CITY OF DOVER

PLANNING TECHNICAL REVIEW COMMITTEE –AGENDA

1. 10:30 AM - 11:30 AM: Site Review for CESO (Owners: 914 Central Avenue, LLC), Assessor's Map 38, Lot 20, zoned C, located at 914 Central Avenue. (Proposal is for Hang Ten Car Wash development that will consist of a 4,400-sf building, sixteen (16) vacuum spaces, and two (2) employee parking spaces. Two (2) related Conditional Use Permit applications would also appear before the Planning Board. (SITE-2023-0008, COND-2023-0045, & COND-2023-0046)
[This item was previously heard on August 17, 2023 and December 21, 2023.]

PLAN SNAPSHOT REPORT SITE-2023-0008 FOR CITY OF DOVER, N.H.

CONSTRUCTION
DETAILS

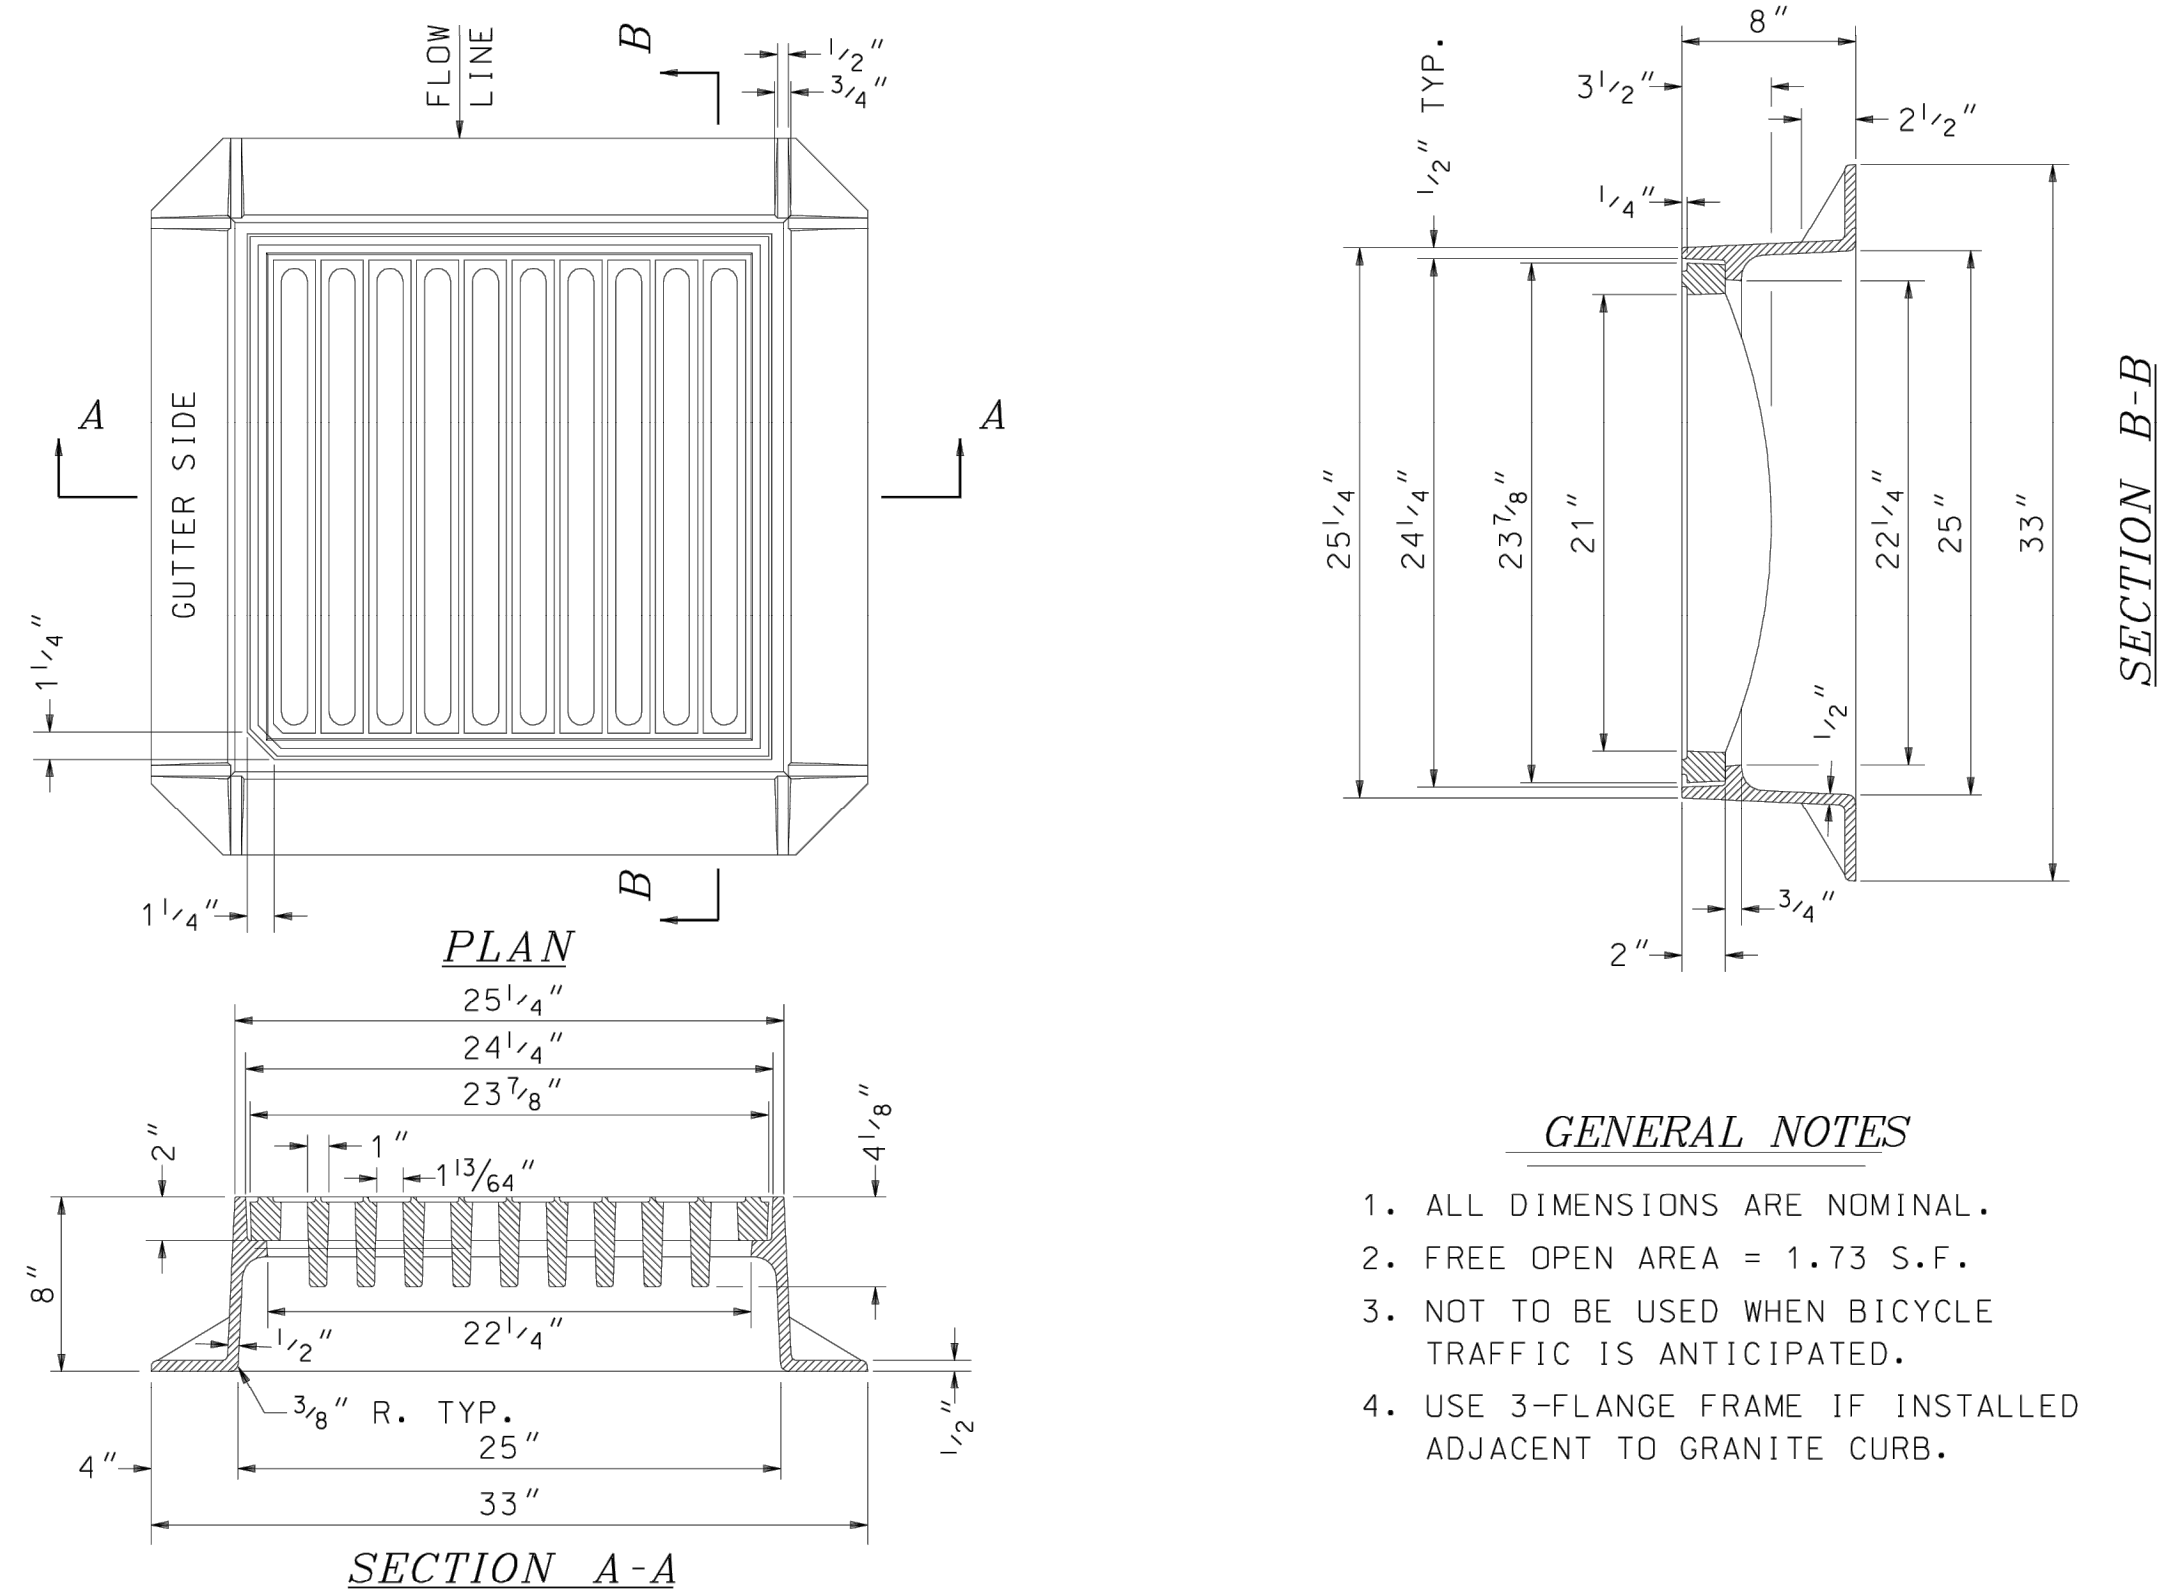
- 8) C6.0:
 - a. Accessible Parking Space Striping – Length of parking space shall meet City of Dover Code Section 153-14, and loading zone shall be 8' min. Detail should be shown as angled to match what is proposed.

Response: Detail has been added and note about impervious liner has been included.
- 9) C6.1:
 - a. Indicate which grate is to be used; Type B is preferred.
